Access Compliance Report

Public Rights-of-Way

Intersection ID: 50592	Main Street: BENDING_BRANCH_RD	Cross Street: BRISTLEY_RD	Location:	N
ADA ID: 2923F1320BD6	Ramp Type: BlendTrans1	Initial Pass/Fail: Pass	Overall Compliance: No	Severity Score: 5.25
Codes/Mitigation Info/Possible Solution		Field Measurements/Component Compliance

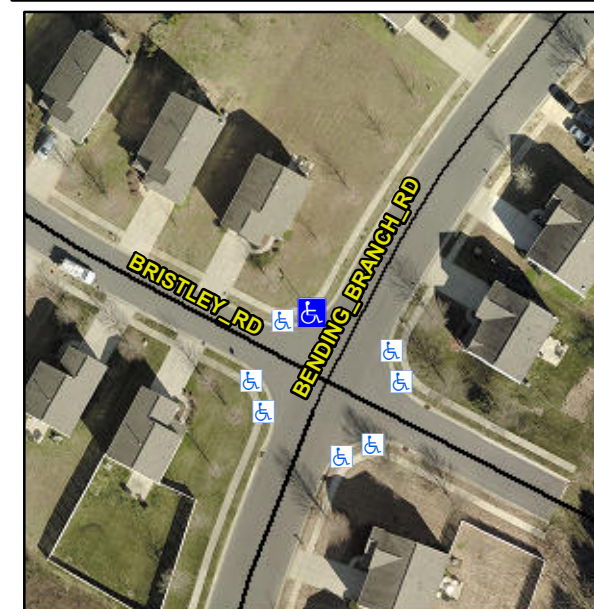
Not Found, R304.2.1, R304.2.2-Perp, R304.3.2-Para, R305.2, R304.5.4

Compliance	Description	Data	Compliance	Description	Data
N/A	Ramp Length (in)	49.0	Yes	BlendTrans Slope (%)	5.0
Yes	Ramp Width (in)	48.0	Yes	BlendTrans XSlope (%)	3.2
N/A	Flare Type LT	Sloped	N/A	Flare Type RT	Sloped
N/A	Flare Slope LT (%)	10.5	N/A	Flare Slope RT (%)	0.3
N/A	Flare Traversable LT?	No	N/A	Flare Traversable RT?	No
No	Landing Length (in)	47.0	Yes	DWS Provided?	Yes
Yes	Landing Width (in)	79.0	Yes	DWS Contrast?	Yes
No	Landing Slope (%)	3.4	Yes	DWS Length (in)	24.5
Yes	Landing X Slope (%)	3.0	Yes	DWS Full Width?	Yes
N/A	Landing Curb? (Y/N)	No	No	DWS Offset (in)	6.5
N/A	Shared Landing?	No			
Yes	Gutter Ponding?	No	No	Gutter Slope (%)	13.8
Yes	Gutter Lip Ht (in)	0.0	Yes	Gutter X Slope (%)	2.7
N/A	Painted X Walk1?	No	N/A	Painted X Walk2?	N/A
	X Walk 1 Direction	To SE		X Walk 2 Direction	N/A
	X Walk 1 Width (in)	N/A		X Walk 2 Width (in)	N/A
	X Walk 1 Slope (%)	1.2		X Walk 2 Slope (%)	N/A
	X Walk 1 X Slope (%)	4.1		X Walk 2 X Slope (%)	N/A

N/A	Ramp inside XWalk1?	N/A	N/A	Ramp inside XWalk2?	N/A
	Road Slope (%)	4.1		Clear Space?	Yes
	Road X Slope (%)	1.2	N/A	Clear Space to XWalk (in)	N/A
Yes	Any Obstructions?	No	Yes	Storm Grate/Utility Hazard?	No
	Obstruction Type			Storm Grate/Utility Type	
		N/A			N/A
			Yes	Surface Condition? (G/P)	Good
			No	Curb Slope (%)	8.9

Remove & Replace Curb Ramp With Two New Directional Ramps or Equivalent. Remove & Replace Gutter.
